E4443A-15

S E R V I C E N O T E

PSA Series Spectrum Analyzers with Options 233 and 110,
and Option Driver Assembly p/n E4440-60253

Tuned RF Level Range 2 to Range 3 Switching Time Improvement

Figure 1. Option Driver assembly location. E4448A shown

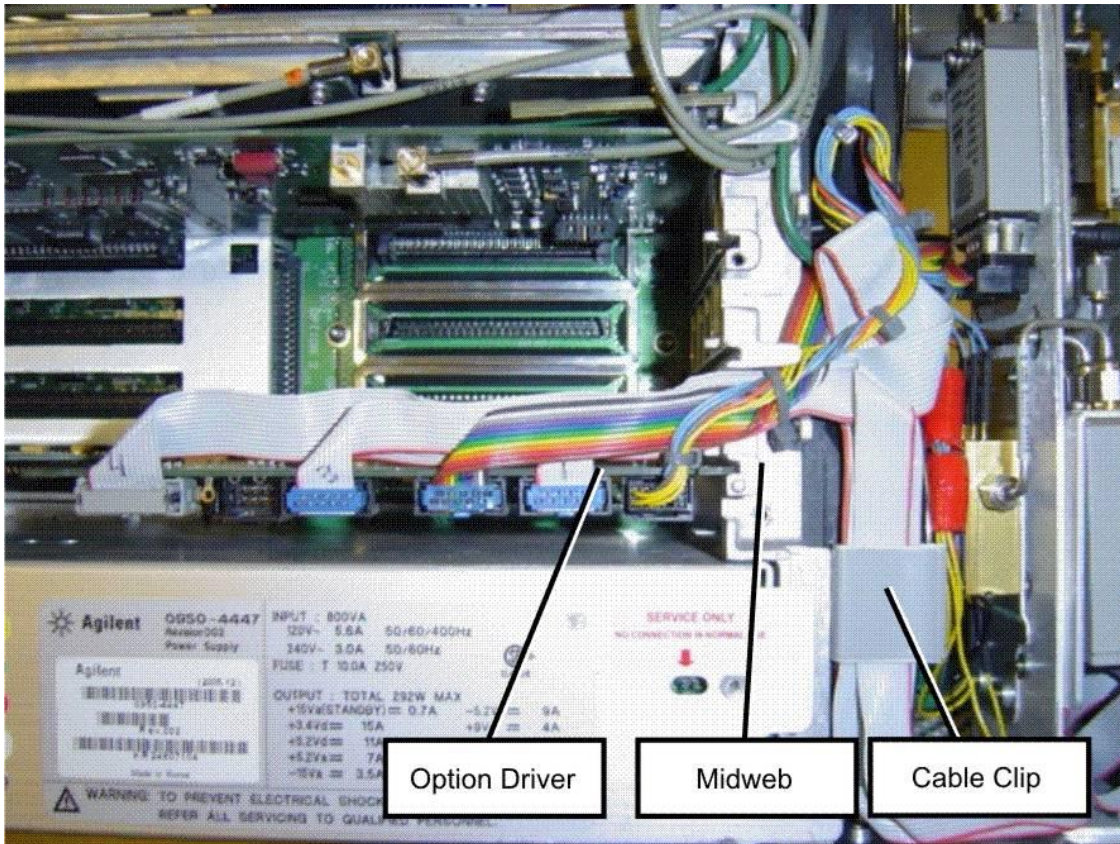
1. Remove the analyzer’s outer case and top brace. See the PSA Service Guide for the procedure to remove and replace these covers.
2. With the instrument powered down, locate the Option Driver assembly shown in **Figure 1**. Notice how the ribbon cables connected to the board assembly are routed near the instrument fans. This routing prevents damage to the cables when the top brace is installed.

3. Without removing any cables from the option driver, carefully unseat the board assembly from the motherboard. You will need to remove the ribbon cables from the cable clip and possibly remove the cable tie near the mid web. Pull the board out of the instrument only far enough to expose connector J2.
4. See Figure 2. Locate J2 near the middle of the board. Connect the ribbon cable from the Parallel Cable's pod to the JTAG connector, J2, on the A38 option Driver Assembly being careful to align the keying tab on the cable with the J2 header slot.
